MEMORANDUM

From:	Tina Cuss Ecology Officer		
Service	WBC Ecology	App No:	260582
Address:	Manor Cottage, Barkham Street, Barkham, Wokingham, RG40 4PJ.		
Proposal:	Householder application for proposed erection of front porch extension, 2 storey side and part 2 storey/single storey rear extension and addition of new site entrance with new front gates alongside walls and railings.		
Type of Development:	Other Householder		
Site Visit Made:	No

Photo 3: Looking south along the boundary of the site showing the tree line which will provide foraging and commuting habitat.

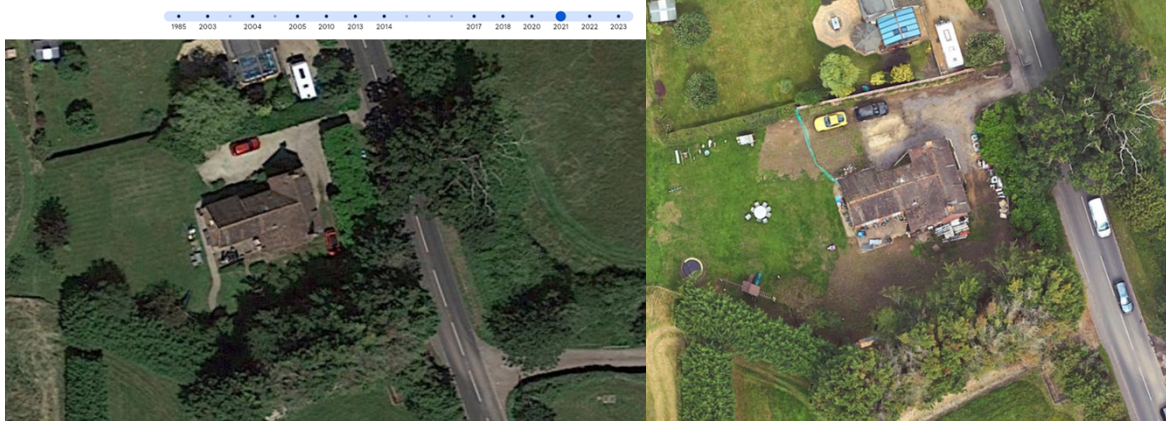
Arbtech describe the large garden contained scattered trees, shrubs and hedgerows which provide foraging and commuting opportunities for bat. They assessed further large trees on neighbouring properties and patches of woodland are all likely provide foraging and commuting opportunities for bats. According to my assessment of Streetview photos, the Arbtech’s description does not match the current degraded condition of the site.

I disagree with the application form, that work including, in particular the construction of the gravel car park and surfacing of the front garden, removal of hedgerows and erection of boundary fences, infilling of the Highway ditch to create and new access have not started. Neither the application form, ESR nor PRA assesses the effects of the grass, shrub and northern hedgerow clearance on bats and other wildlife and the loss of biodiversity habitat contrary to planning policy.

ESR-25/29.06 does not address the loss or negative impacts to interconnected tree lines and hedgerows along field boundaries that created a network of commuting routes for bats, connecting to the surrounding area. Clarification must be provided whether southern and eastern boundary hedges were cleared before the emergence surveys commenced or the ESR failed to assess the changes in the on and off-site commuting corridors and consider whether this impacted bat commuting and
